Goulburn Mulwaree Council Preliminary Comments
Goulburn Base Hospital Redevelopment
130 Goldsmith Street, Goulburn (Your Ref: SSD 8667)

Heritage Referral Response

Figure 1. Demolition Plan and proposed new building footprints

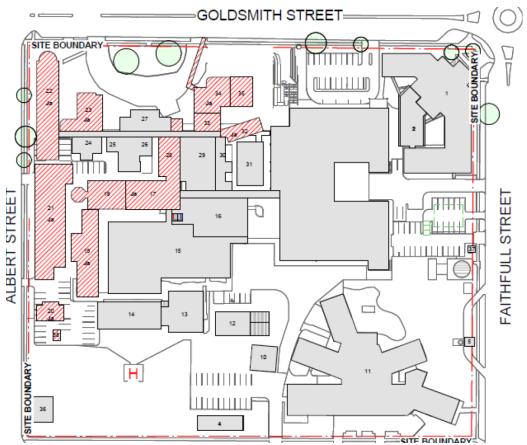
The proposed four storey building is to be located in the position of the Springfield House and Lady Gross House. It will be a prominent modern building that will provide a contemporary contrast to the fine grained architectural detail of the original 19th century buildings. The original buildings will still be front and centre and views to them will be improved by removal of the building on the corner of Albert and Goldsmith Streets. In addition the removal of the entry ramp and admissions building will improve the view from Goldsmith Street. The original carriage loop will be retained along with original trees, two Cedars of Lebanon and a Canary Island Date Palm.

The significance of these two building will be lost in the proposed development. Both buildings were subject to modifications in the 1950s and 1960s.

In general the proposed development has been carefully designed with consideration to the heritage values of the site and has achieved the retention of the most important buildings. The removal of some of the buildings graded as moderately significant is considered acceptable in the context of enabling the ongoing and continuous use of the site for its original and intended purpose. It is also recognised that hospitals as a building type are subject to ongoing pressure for change in order to avoid obsolescence.

- 2. The revised landscape plan should provide greater visibility of the 19th century Hospital buildings. The screening to the road should be removed.
- 3. Prior to Commencement: An archival record must be made of all buildings designated to be of moderate significance prior to any demolition. The record shall be prepared according to the documents published by the NSW Office of Environment and Heritage: Heritage Guidelines, How to prepare archival recordings and Photographic recording of heritage items using film or digital capture. The archival record is to be made prior to any works taking place.

Figure 2 The SoHI grading of the relative heritage value of these buildings:

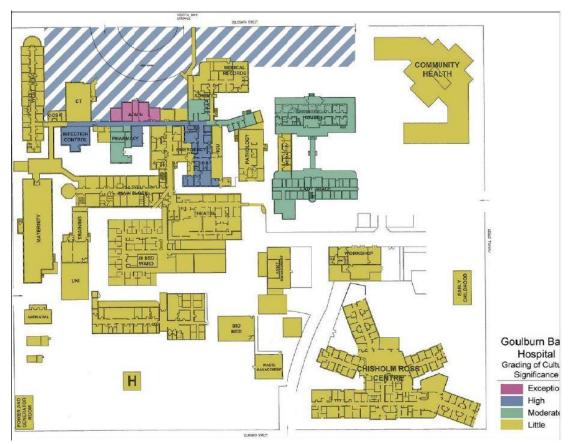
According to the SoHI the following buildings with moderate significance will be impacted by demolition or extensive refurbishment:

- The Community Health Building (Springfield House)
- Lady Gross House
- Pathology Speciman Collection
- Reception
- The emergency department

According to the SoHI the Springfield House and Lady Gros Home have heritage value: Springfield House (1927-28) and Lady Grose Home (1939) are both good representative and competent examples of Inter-war period buildings that despite some changes, alterations and additions retain a strong sense of their original character and details including face brick facades, open verandahs and balconies, timber windows and doors and roof form. Both buildings are relatively large and robust and due to the openness and low scale of the eastern section of the site are visually prominent elements. The front setback is significant and enhances the visibility of Springfield House.
